# SERVICE BULLETIN

**Service Bulletin No.:** DA20-52-01 - Rev. 0

**Date Issued:** 10 December 2012

**Title:** Canopy Locking Mechanism Inspection and Adjustment

Figure 1 – Canopy Locking Mechanism Placard Installation

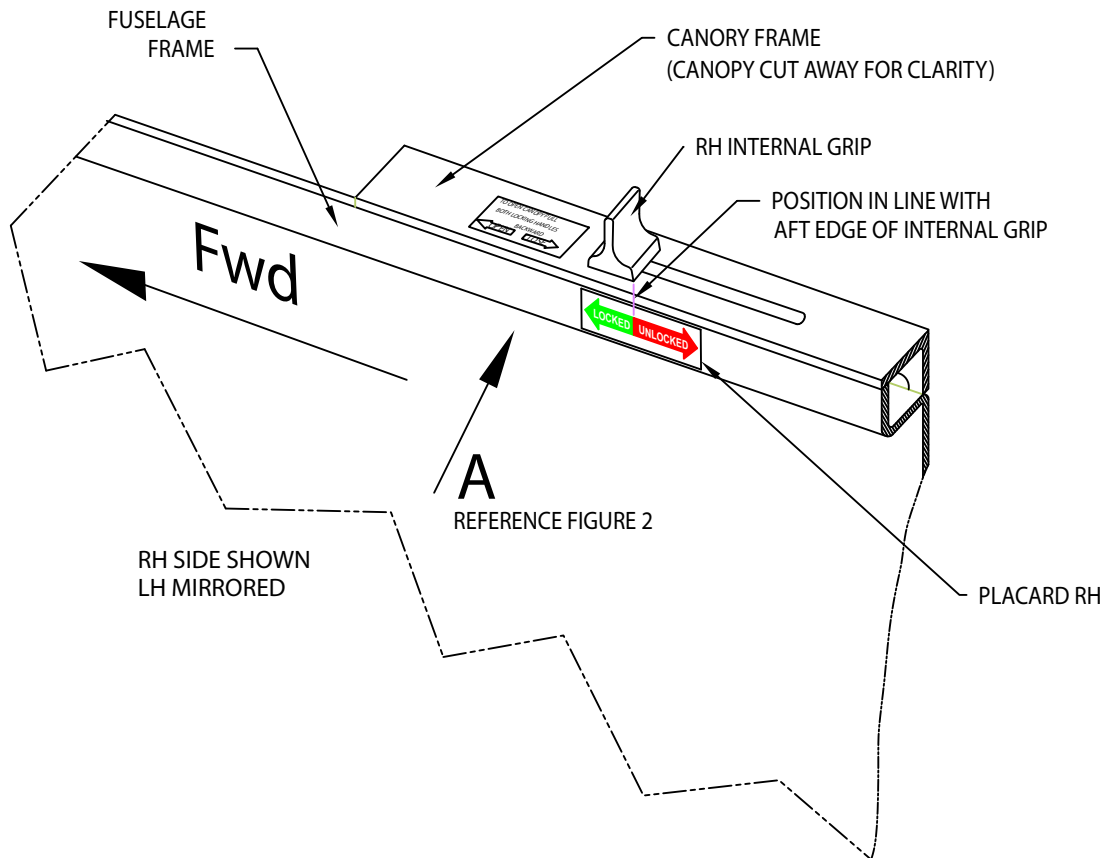
- 
- 1. ATA Code:** 5200
- 2. Effectivity:** All DA20-A1 Aircraft.
- 3. General:** This Service Bulletin addresses the introduction of:
- a. the canopy locking mechanism position placard.  
This is done to make sure that the canopy is closed and locked correctly.

10.3.5 Install Placard LH, Locking Mechanism Position (P/N 20-1130-00-28) as shown in Figure 1.  
Make sure that the aft edge of the green sector on the placard is in line with the aft edge of the internal grip.

NOTE: Perform the placard installation after all tests and adjustments are completed.

10.3.1 Clean the area on the interior surface of the fuselage under the internal grip for placard installation with isopropyl alcohol or similar cleaning solution. Refer to the Material Safety Data Sheet (MSDS) for handling of chemicals.

10.3.2 Close and latch the canopy LH and RH sides.

10.3.3 Move the LH internal grip aft to the point when the annunciator starts to illuminate but before the bushing on the aft locking pin passes the top of the cam on the locking shoe (defined by the increase in unlatching force).

10.3.4 Move the LH internal grip forward 1 to 2 mm.

10.3.6 Move the LH grip to the locked position.

Figure 2 – Canopy locking Mechanism

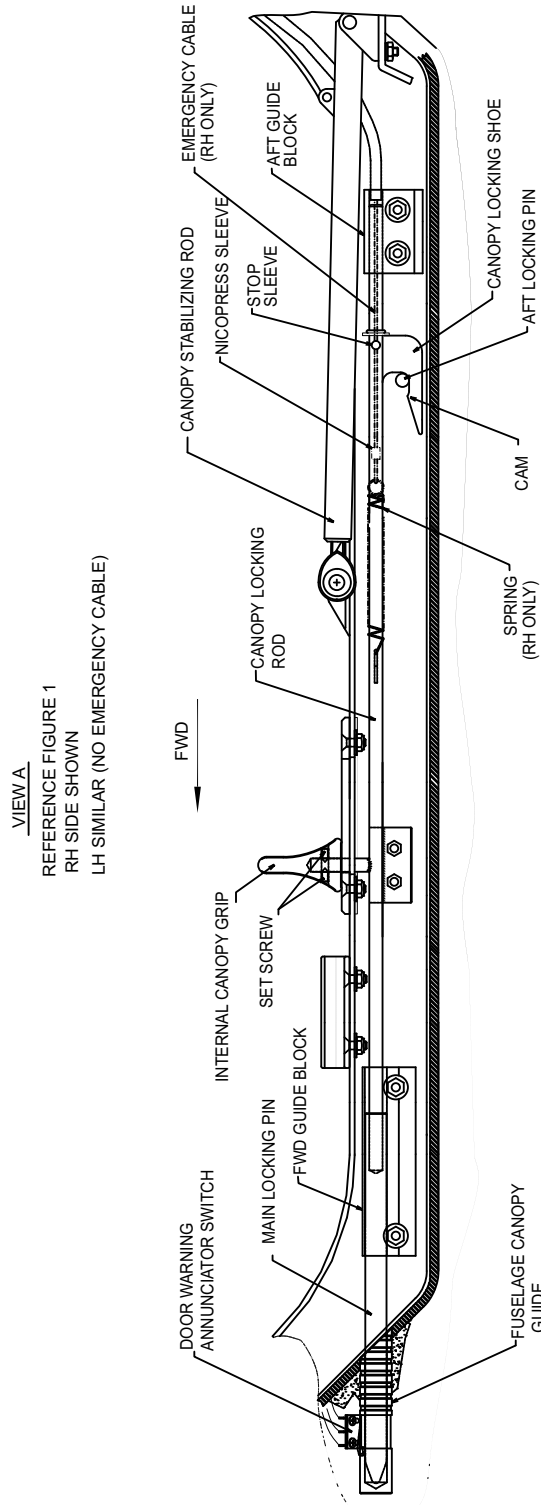
- b. the optional (oversized) bushings for the installation on the aft locking pins.  
This is done to simplify the procedure of the canopy locking mechanism adjustment (eliminated the need of the composite repair during the adjustment of the locking mechanism).

- c. the procedure for the canopy locking mechanism adjustment and test.  
This is done to improve the inspection criteria and to make sure proper operation of the canopy locking mechanism.

Refer to Figures 1 and 2 for further information.

10.1.8 Measure the force required to unlatch the LH locking mechanism using a calibrated spring scale on the LH external grip, pulling directly aft. The unlatching force must be 58-80 N (13-18 lbf).

NOTE: During unlatching movement of the handle, there should be a distinct increase in unlatching force when the aft locking pin passes the cam on the canopy locking shoe.

NOTE: If the canopy seal has been replaced recently, it is recommended to adjust the unlatching force to near the upper end of the tolerance.

10.1.9 If necessary, replace the bushing on the aft locking pin with oversized pin Ø10.2mm (P/N 20-5650-00-05) or pin Ø12.2mm (P/N 20-5650-00-06) to achieve required unlatching force.
